Application Number SSD-10464

50-52 Phillip Street New Hotel/Residential Building Stage 1 Concept DA

Statement of objection

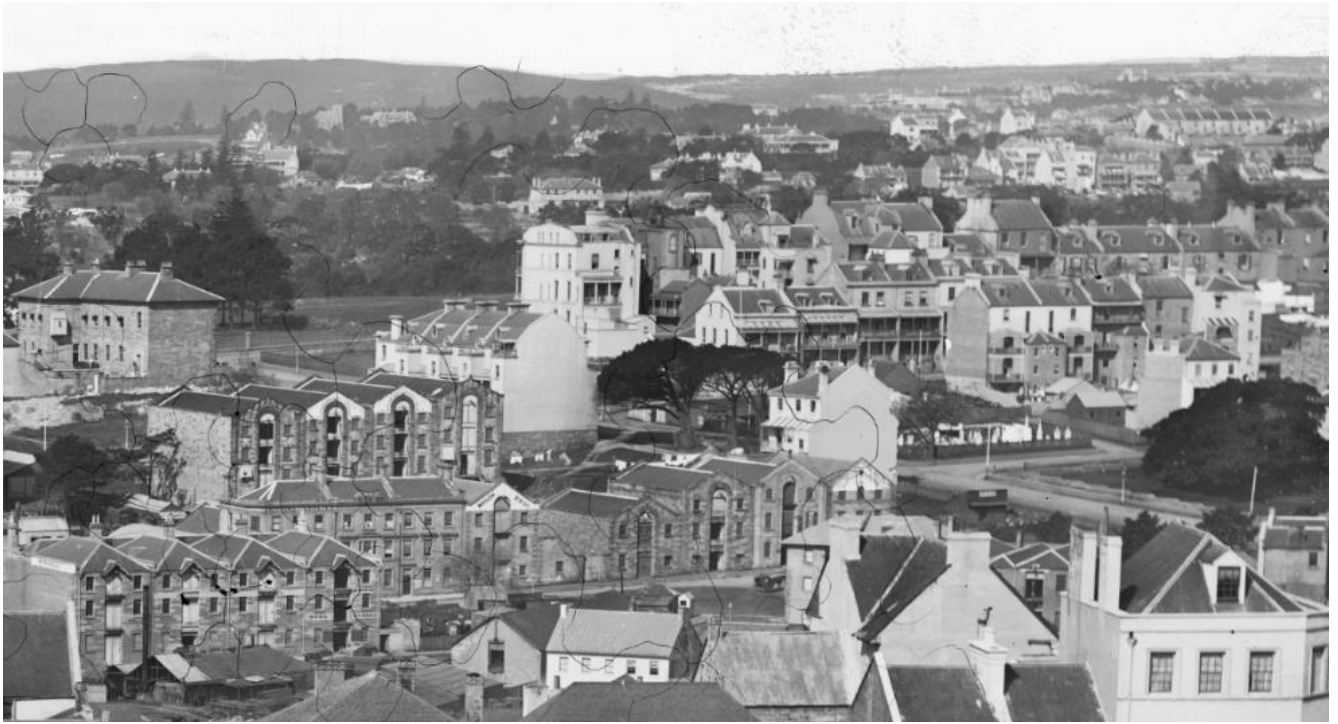
The Figure below shows the obvious location for on-site pick-up and drop-off. This works best if the one-way direction on Phillip Lane is reversed, so that vehicles arrive at the drop-off directly rather than travelling the length of Phillip Lane. This pick-up and drop-up arrangements requires minimal removal of significant fabric.

1. No rear extensions at podium level
2. No re-grading of Phillip Lane
3. No residential use
4. On-site pick-up and drop-off
5. No reduction in views of Chief Secretary Building from The Astor or Phillip Lane
